STATE OF MAINE  
DEPARTMENT OF TRANSPORTATION  
16 STATE HOUSE STATION  
AUGUSTA, MAINE 04333-0016

July 17, 2018  
Subject: Wharf Infill & Building  
Removal  
State WIN: 021942.06  
Location: **Portland**  
**Amendment No. 2**

UTILITY POLE AND FOUNDATION DETAIL  
N.T.S.

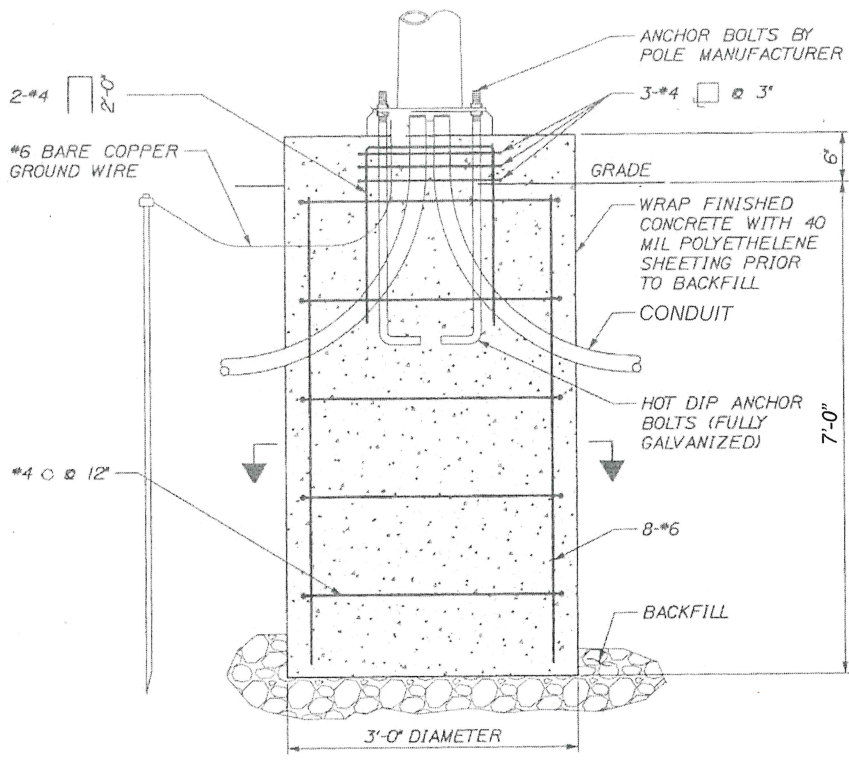
**ADD** the attached Utility Pole and Foundation Detail, 1 page.

**Question:** Special Specifications Section 634, Highway Lighting 634.01 Item 10 calls for a new 30' aluminum pole and concrete base. Can you please provide specifications for the pole and base?

**Response:** The pole shall be a 12-inch diameter pole, straight shaft steel ASTM 513 of 0.25-inch thickness (min.), which conforms to the MaineDOT Standard Specification Section 707 – Metallic Pipe. The pole shall be galvanized and shall have one handhole opening of approximately 4 inches by 6 inches located 24 inches from the base of the pole.

The concrete base shall be a 36-inch diameter foundation with the dimensions and details as shown in the attached sketch. The foundation shall be fabricated and installed in accordance with the MaineDOT Standard Specification Section 626 – Foundations, Conduit, and Junction Boxes for Highway Signing, Lighting, and Signals.
